PLAN
SHOWING PROPOSED BUILDING ON PLOT No 3A J.R. II
JERAI QUARTER
SCALE 8" = 1" HCH

KARACHI MUNICIPALITY.

With reference to your application dated 37.3.1932, with a plan for the proposed building/additions and alterations on plot No. 3A, Survey Sheet No. 8A.11, Loran quarter I have the honour to inform you that until the following requirements are complied with plans cannot be passed:—

Date of disposal

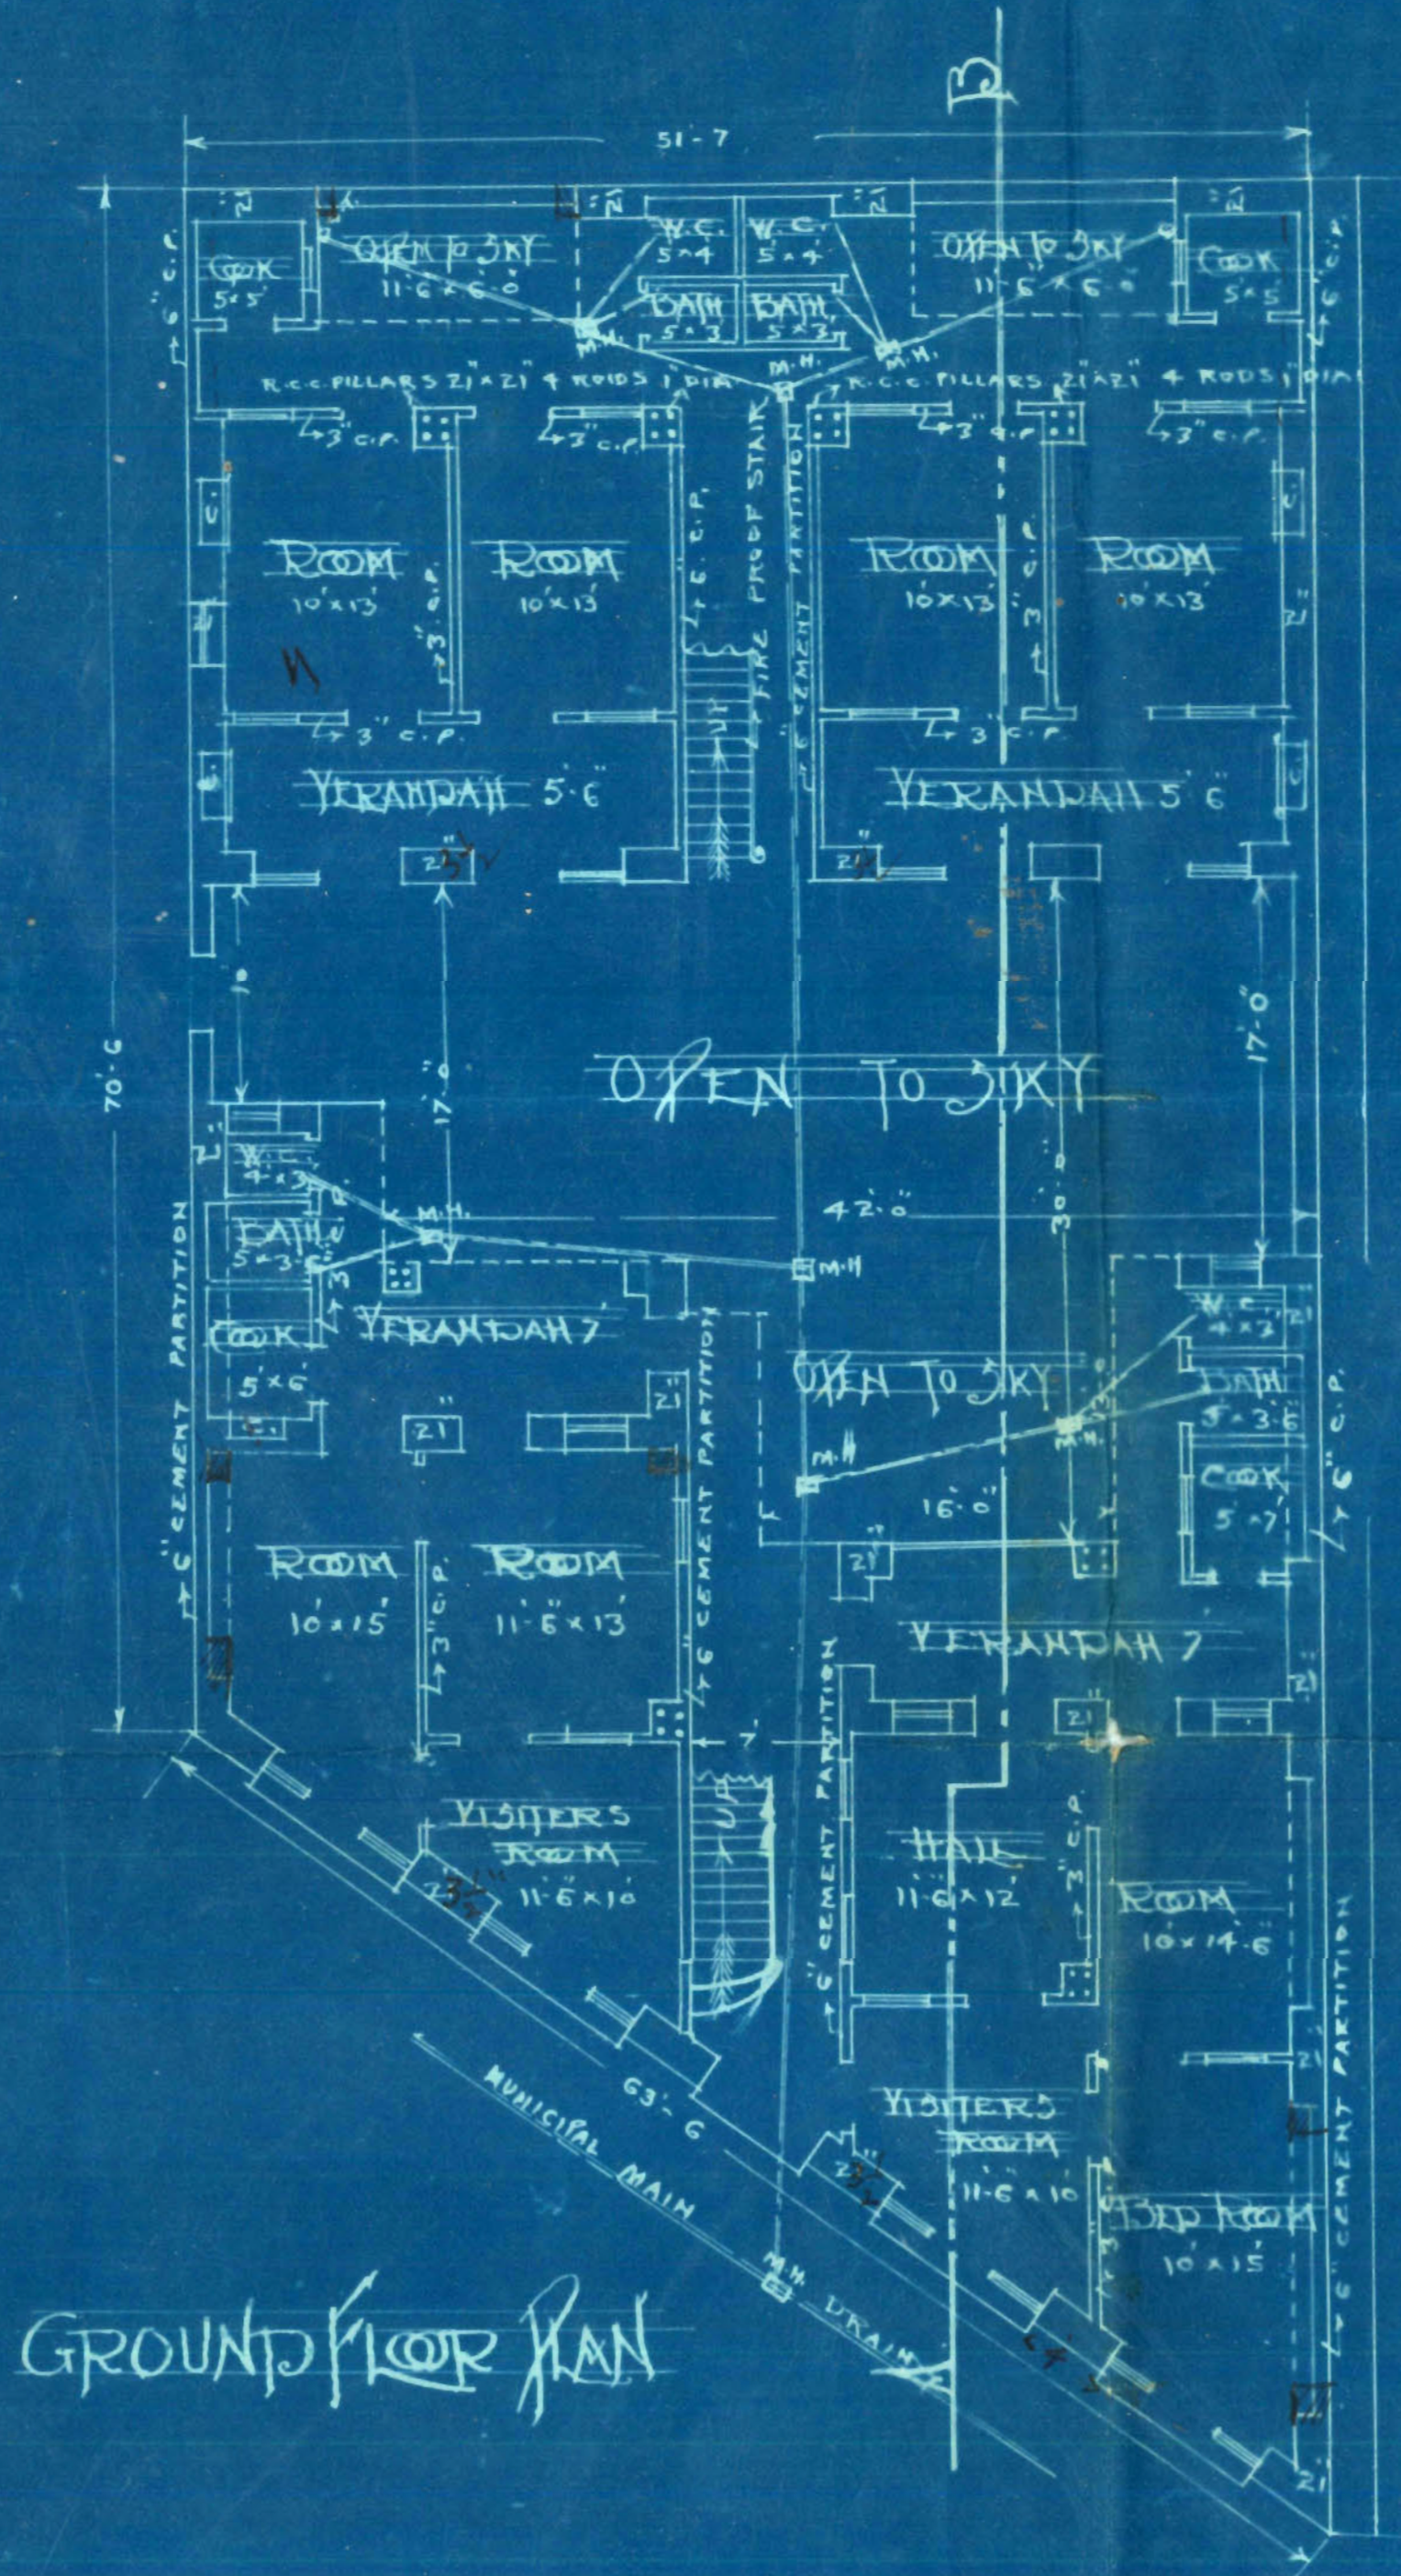
- (1) Size of front pillars must be increased & put down on plan.
- (2) Beams must be provided at A & B as marked in R.C.C. Plan.
- (3) Plans must be corrected as done in ink in the plan.
- (4) Both the stairs on all floors be fireproof
- (5) Front wall must be ~~23~~ $23\frac{1}{2}$ " 21 " $18\frac{1}{2}$ " & $18\frac{1}{2}$ "
- (6) Partitions along the stairs be 6" thick.
- (7) R.C.C. Columns must be 5' square at the base
- (8) Calculations for the load on pillars must be submitted clearly. They must be R.C.C.
- (9) Section must be corrected as shown in ink in the plan
- (10) Right of passage & easement on the N.W.R. Plot be produced
- (11) Room No. must have 6' open in front of it.
- (12) Central passage be taken 8' at the least.

With reference to your letter No: L.M.A.B.S.P. 156 dated 16/4/32 regarding plan of building on plot No: 3 A sheet S.R. 11 Serai Quarter we beg to return the plans duly amended.

With regard to your objection No: 10, we beg to point out that our client has got right of easement on the N.W.Ry plot for which correspondence is going on with the Ry: Executives. We have shown the existing openings in our client's wall on the Ry: plot and which can be verified by you.

Regarding your objection No: 11, the open space left by us is more than what is required throughout excepting in front of a little bit in the Northern corner which can be permitted by you.
